ITEM: 6.2	COMMITTEE OF ADJUSTMENT REPORT SUMMARY MINOR VARIANCE APPLICATION FILE NUMBER A028/23 24 DUNROBIN CRESCENT, KLEINBURG
------------------	--

**COMMITTEE OF ADJUSTMENT REPORT
MINOR VARIANCE APPLICATION
A028/23
24 DUNROBIN CRESCENT, KLEINBURG**

ITEM NUMBER: 6.2	CITY WARD #: 1
APPLICANT:	Raza and Humara Naveed
AGENT:	None
PROPERTY:	24 Dunrobin Crescent, Kleinburg
ZONING DESIGNATION:	See below
VAUGHAN OFFICIAL PLAN (2010) DESIGNATION:	Vaughan Official Plan 2010 ('VOP 2010'): "Low-Rise Residential" and "Natural Areas"
RELATED DEVELOPMENT APPLICATIONS:	None
PURPOSE OF APPLICATION:	Relief from the Zoning By-law is being requested to permit access to a proposed secondary suite.

SITE PLAN — 24 Dunrobin Cres

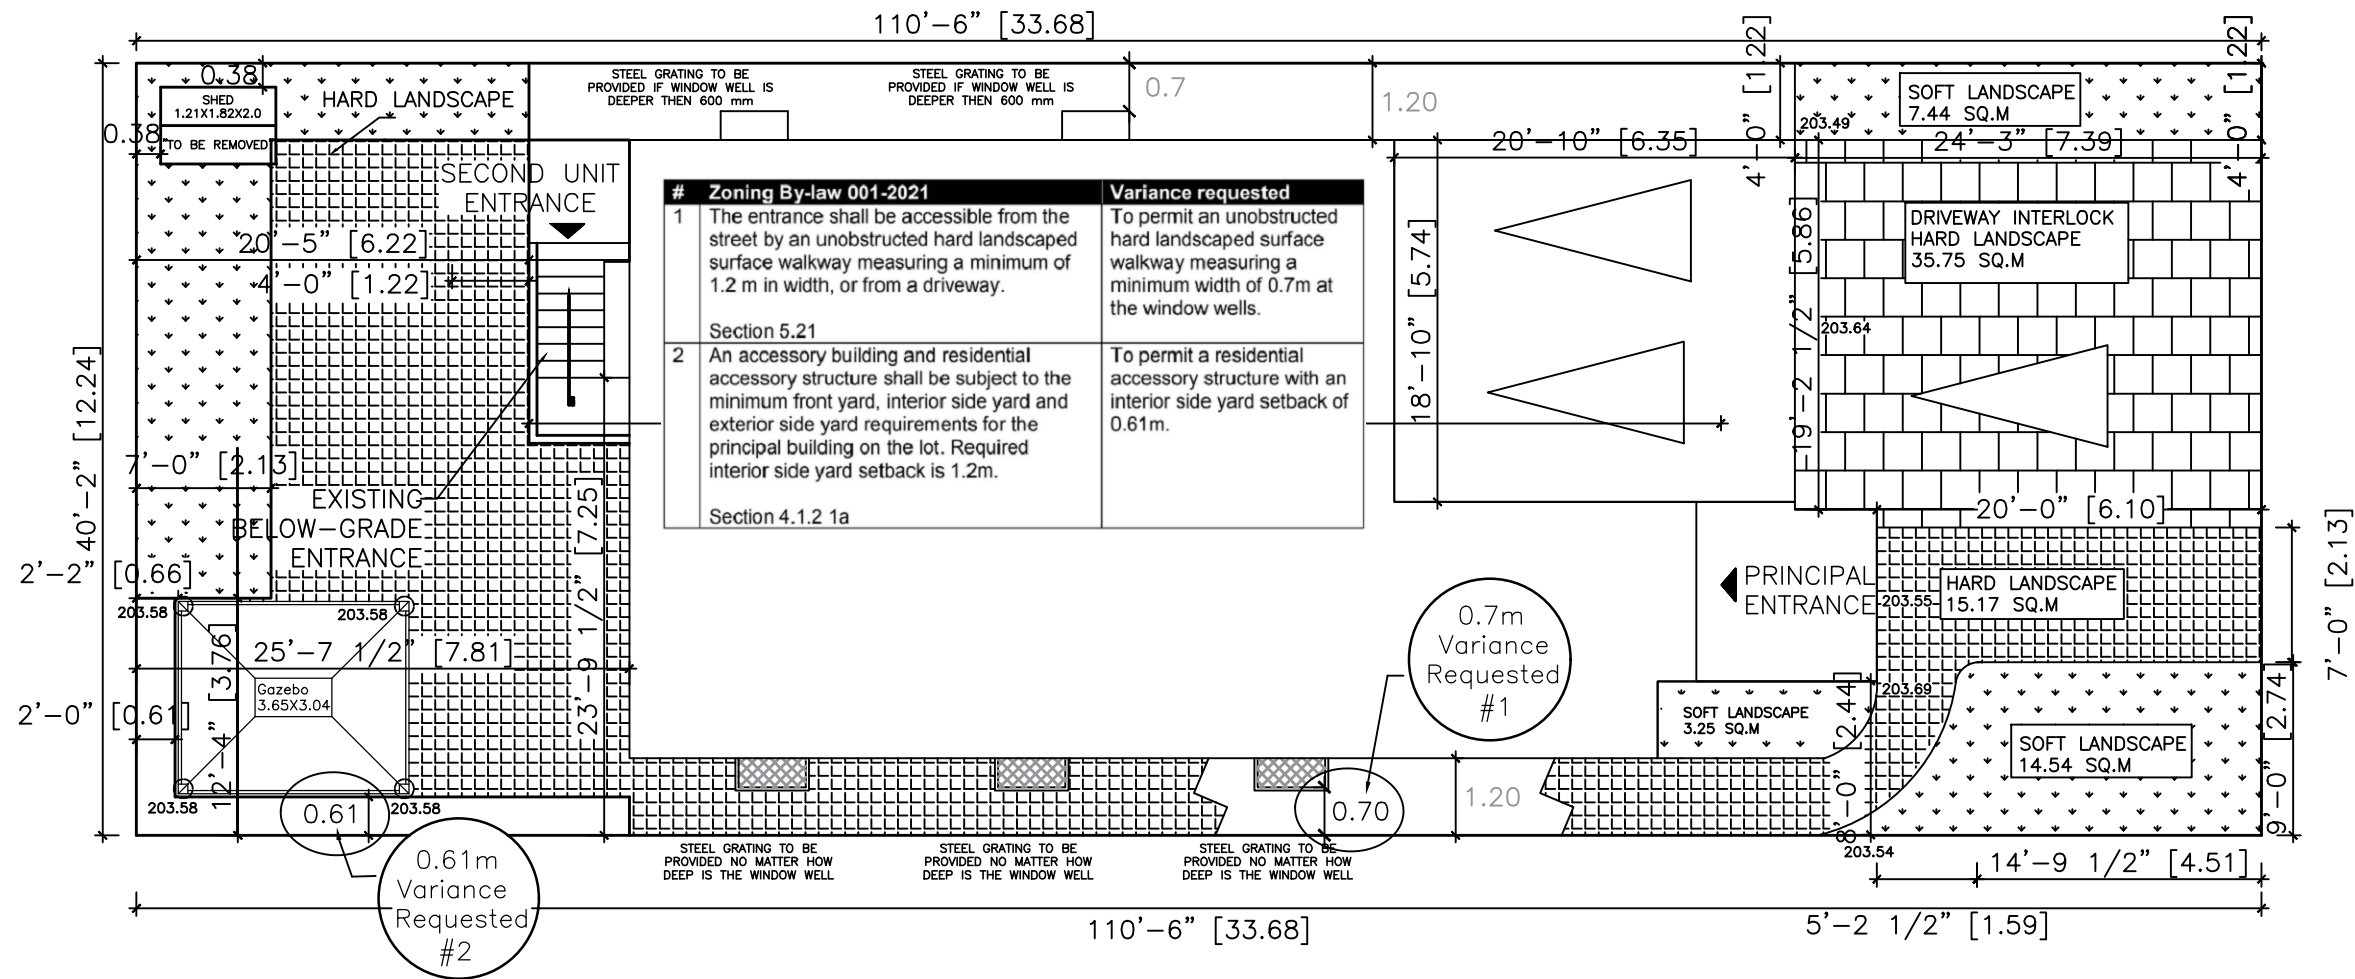
The Development Planning Department has no objection to Variance 1 for the proposed walkway. Three window wells exist where the walkway is proposed. The pathway would narrow to 0.70 m in-front of the window wells. The window wells project minimally above grade and will not impede safe access to the secondary suite. The hard landscape walkway maintains the required 1.2 m clear path to the secondary suite entrance at all other locations.

The Development Planning Department has no objection to Variance 2 for the proposed gazebo. The gazebo complies with the height requirements of the Zoning By-law. Due to its modest height, the reduced interior side yard setback is not anticipated to have adverse impacts to the neighbouring properties and maintains an appropriate area for maintenance access. The Development Engineering Department has also reviewed the proposal and is satisfied that drainage in the rear yard will be maintained.
